City of Portland, Maine – Building or Use Permit Application 389 Congress Street, 04101, Tel: (207) 874-8703, FAX: 874-8716

Location of Construction: 44 West Shore Dr GDI Lot 3 West Shore Drive		Owner: John & Frances Harper	Phone:	Permit No. 980165
Owner Address:	Lessee/Buyer's Name:	Phone:	Business Name:	<div style="border: 2px solid black; padding: 5px; text-align: center;"> PERMIT ISSUED PERMIT ISSUED: MAR - 4 1998 CITY OF PORTLAND </div>
Contractor Name: Eric Weinschenk Builders	Address: 91 Summer Place	Phone: 828-3900		
Past Use: Vacant Lot	Proposed Use: 1-fam dwelling	COST OF WORK: \$ 168,000	PERMIT FEE: \$ 889.00	Zone: CBL: B-A-003 Zoning Approval: Special Zone or Reviews: <input type="checkbox"/> Shoreland <input type="checkbox"/> Wetland <input type="checkbox"/> Flood Zone <input type="checkbox"/> Subdivision <input type="checkbox"/> Site Plan maj <input type="checkbox"/> minor <input type="checkbox"/> mm <input type="checkbox"/>
Proposed Project Description: Single Family Dwelling		FIRE DEPT. <input type="checkbox"/> Approved <input type="checkbox"/> Denied	INSPECTION: Use Group: Type: Signature: <i>[Handwritten]</i>

BUILDING PERMIT REPORT

SUBJECT: Certificate of Occup

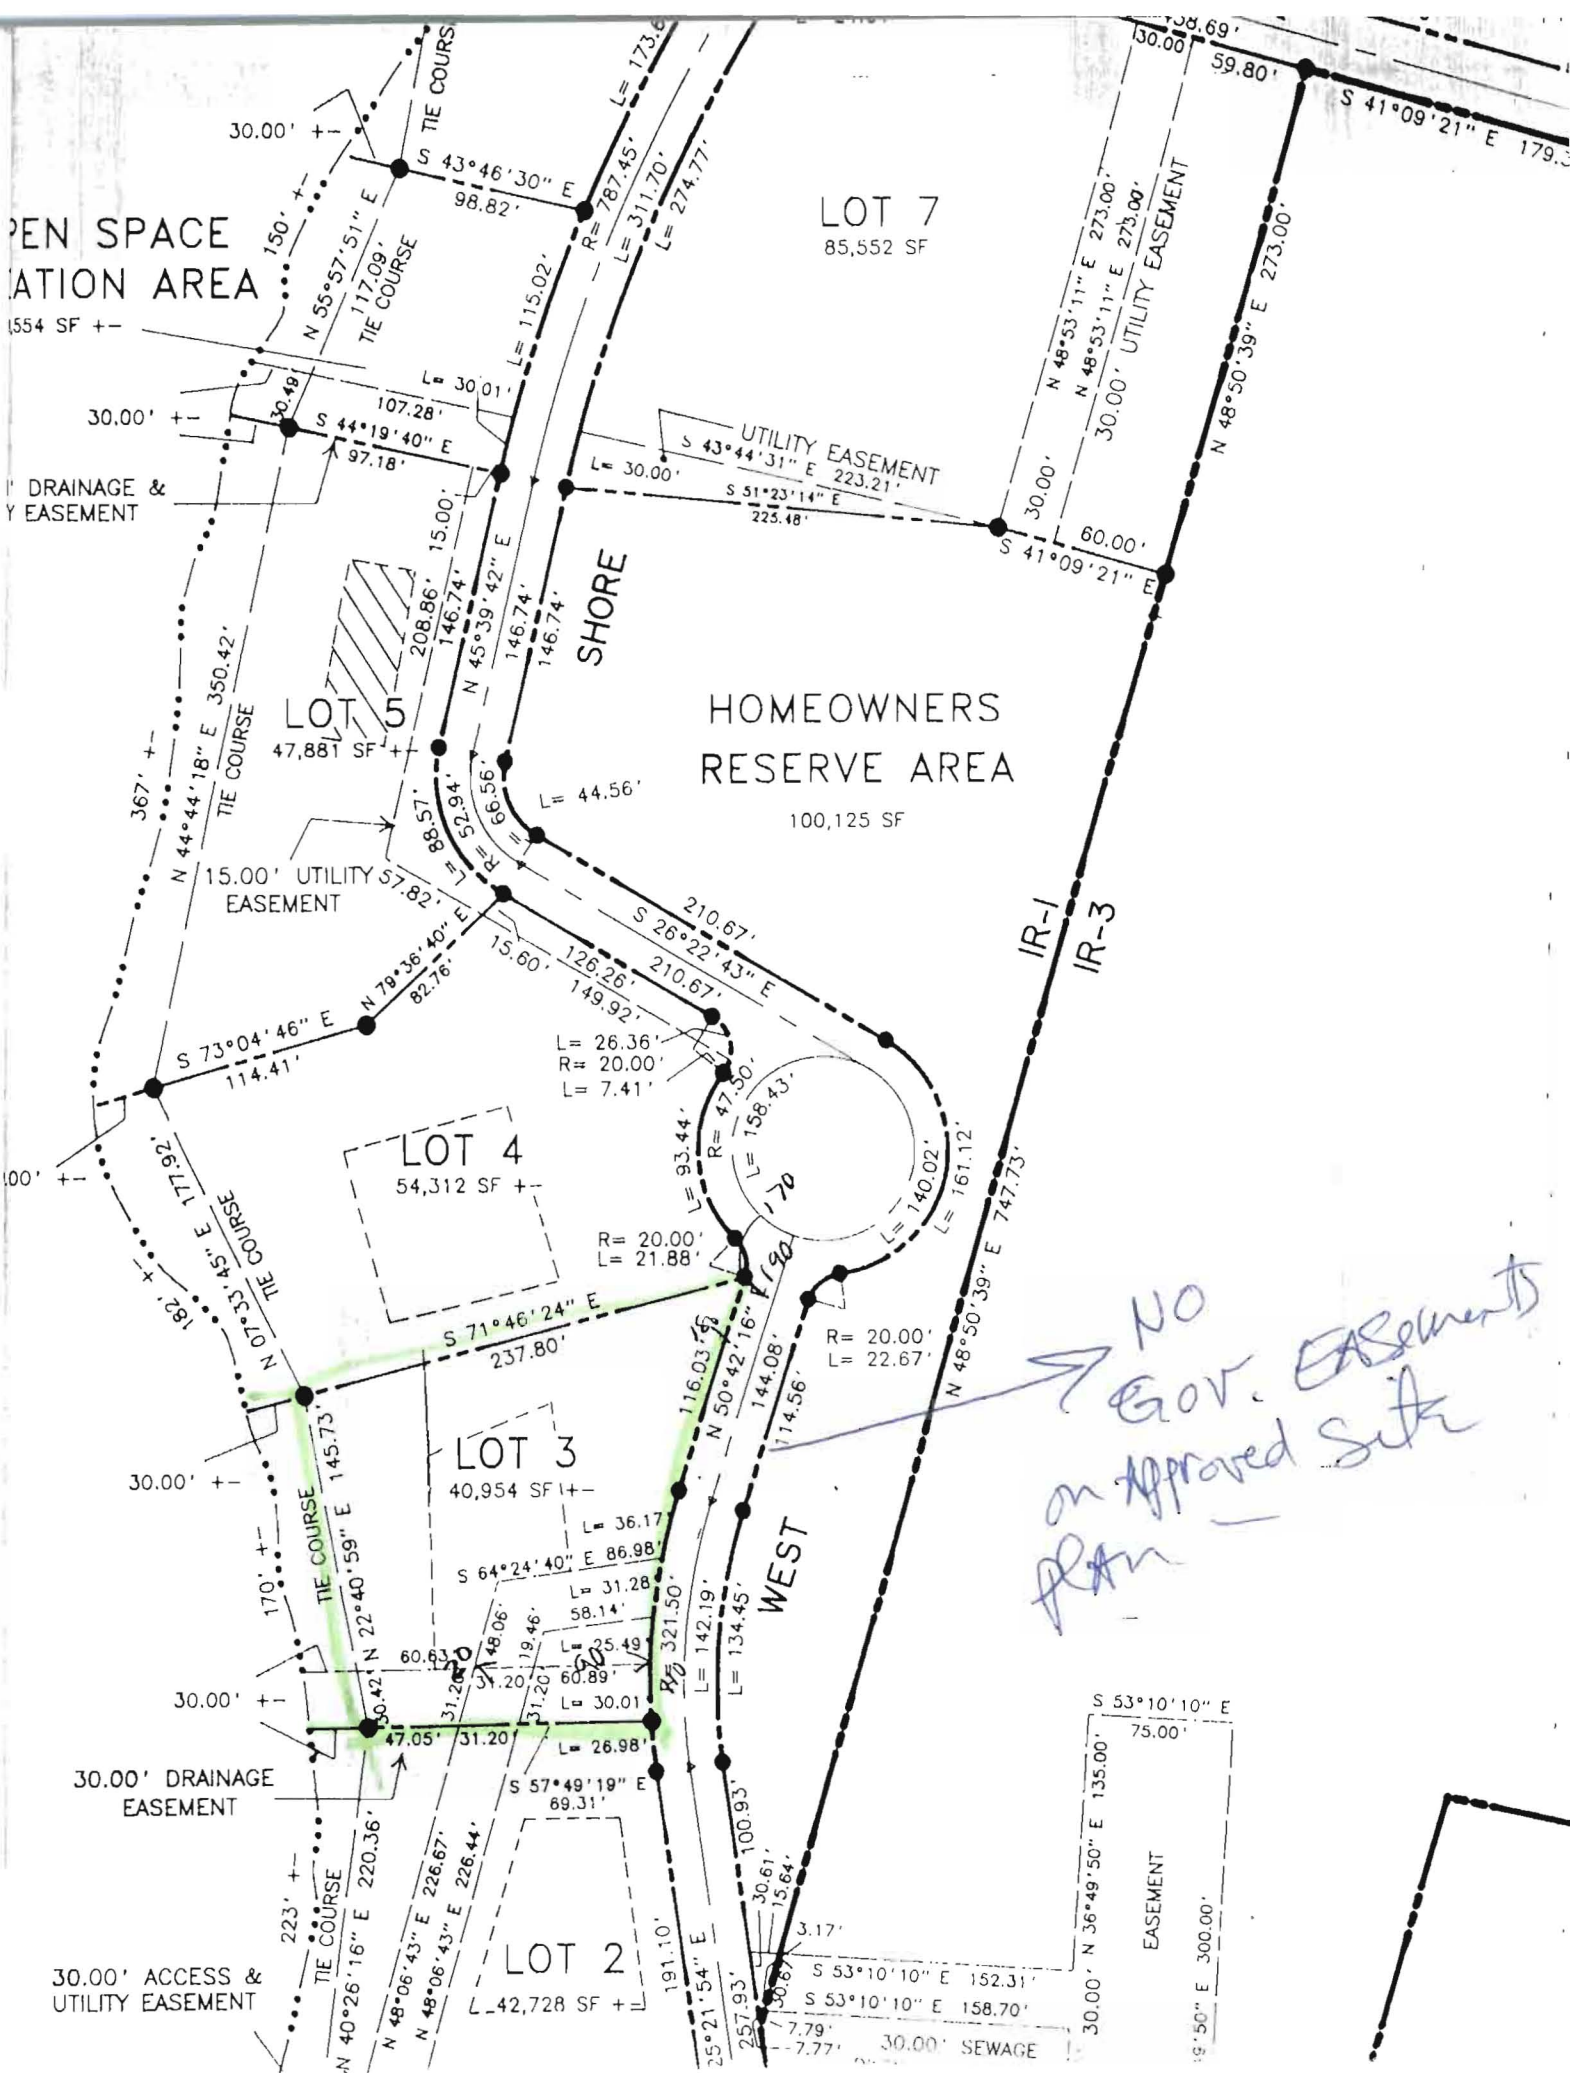
office area needs home occupation permit shows a 20' US Gov right of way → APPROVED SITE PLAN (RECORDED) SHOWS THE US GOV. TO BE GONE

*NO
Gov. Easements
on approved site
plan*

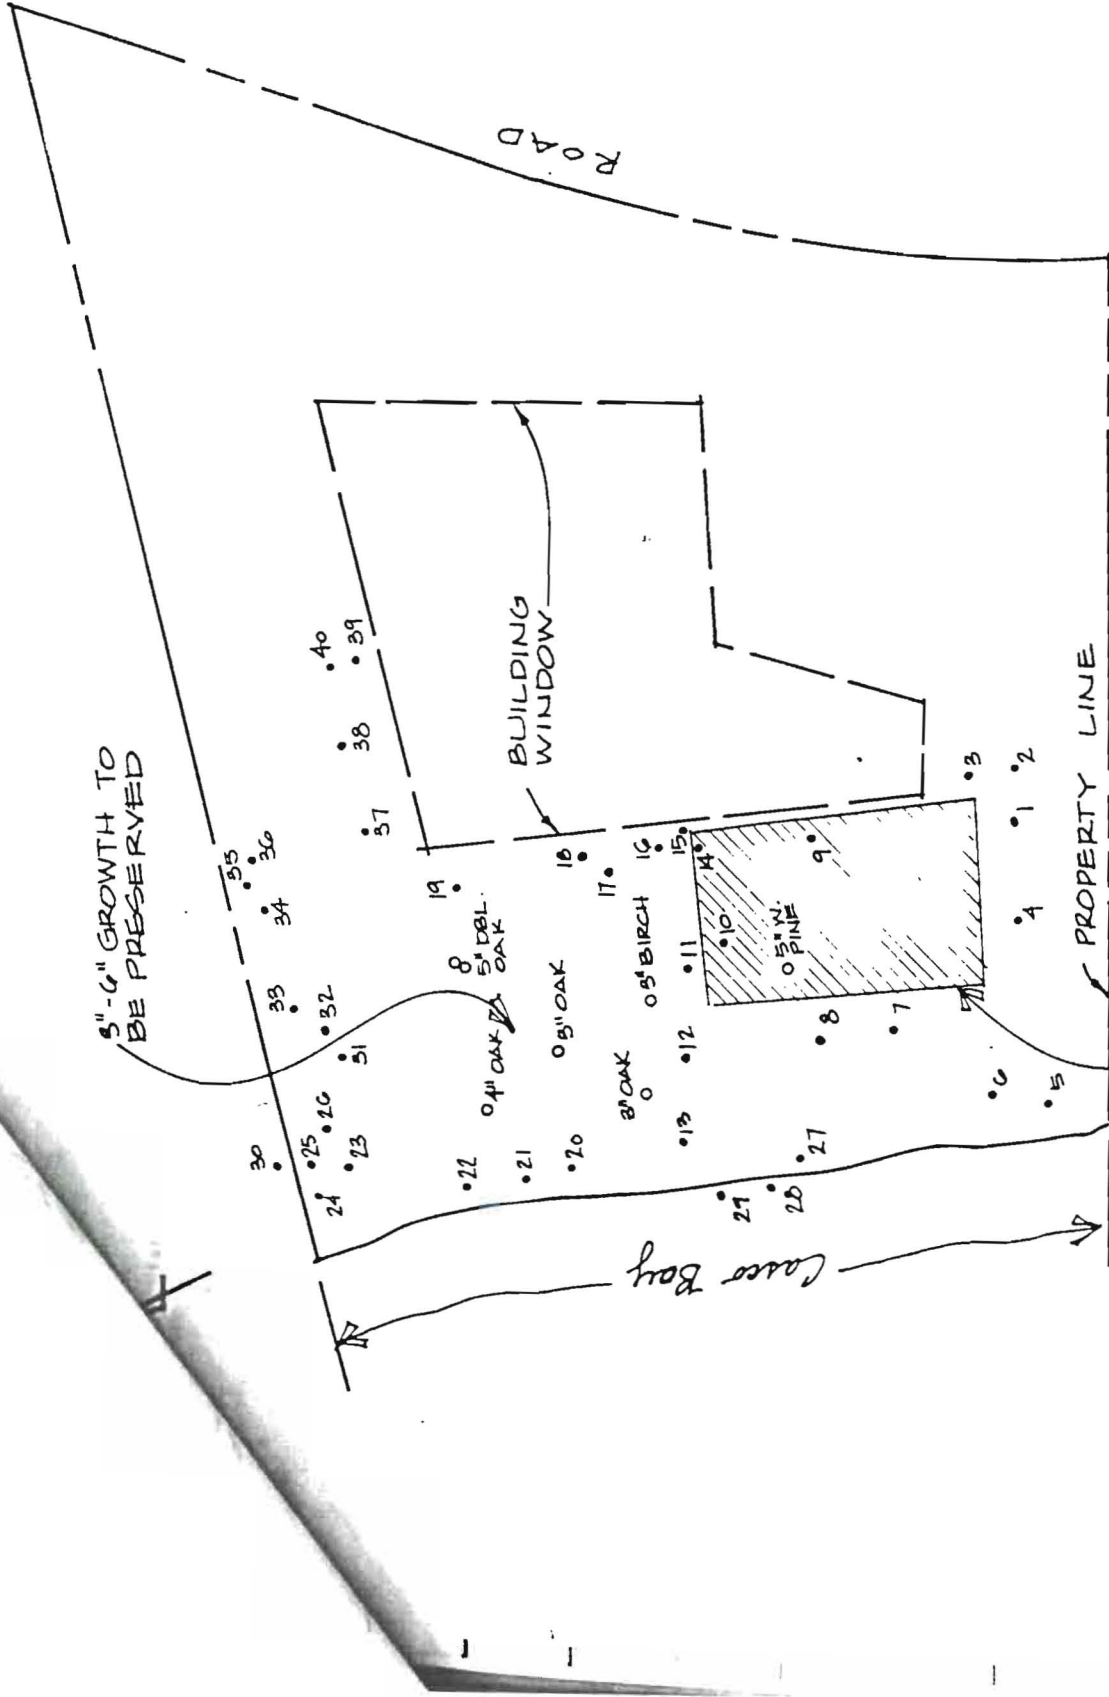
1. No trees greater than 4" at chest height will be cut in the 75' buffer, other than the two oaks that are protruding horizontally out of the bank.
2. These two oaks will be replaced by two- 2 1/2" to 3" caliper oaks in about the same locations, as close to the beach as practicable. We have shown them on Sheet C-4, just above the riprap.

3. The grading above the riprap will vary in pitch. It will match each end and slope around the 10" pine tree. Small stones will be used to protect the pine tree. We have modified Sheets 2/4 and 3/4 to reflect the grading.

4. The foundation drain pipe needs to be lower than the existing storm drain outlet to protect the slope. This installation will be as shown on Ric Weinschenk's plan and will vary in the actual location to avoid trees. This installation and the transport of rock to the shore must be done without cutting trees.

5. The exposed earth above the riprap will be seeded and covered with a jute mat that is biodegradable. In addition to the two oaks, small shrubs may be installed in some locations through the matting.

6. The existing 4" pipe and 12" storm drain will be extended through the riprap. The existing pipe and headwall will not be disturbed.
7. The alignment of the riprap is to be along contour 6 and not in a straight line. The intent is to make the appearance as natural as possible.
